IREDELL COUNTY HEALTH DEPARTMENT

IMPROVEMENT PERMIT / AUTHORIZATION TO CONSTRUCT / OPERATION PERMIT / EXISTING SYSTEM INSPECTION

PERMIT# 040898 PIN# 4729-04-3838 DATE 8/3/00

SUBDIVISION John S Key Sub BLOCK / SECTION - LOT 6+7 LOT AREA ≥ 40,000 ft² SITE CLASS. PS DESIGN FLOW 360 L.T.A.R. 0.25

INITIAL SITE SKETCH

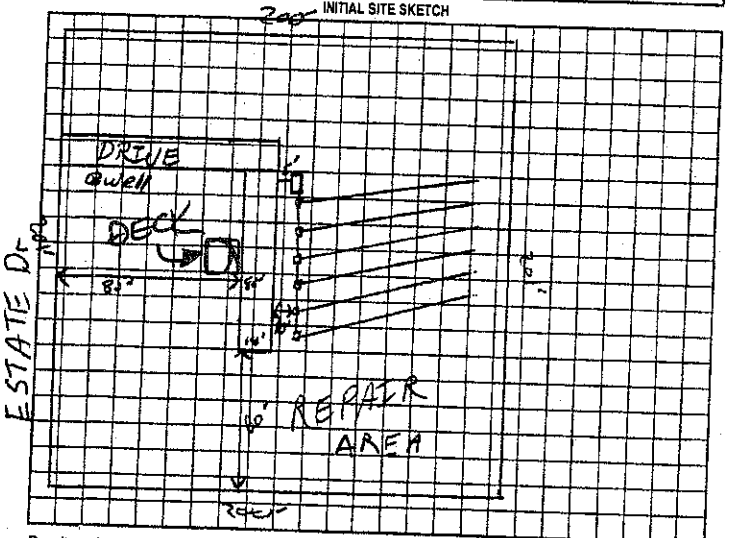
Comments/Conditions: Keep well minimum of 50' from system - Install lines on Contour 1:60 Scale
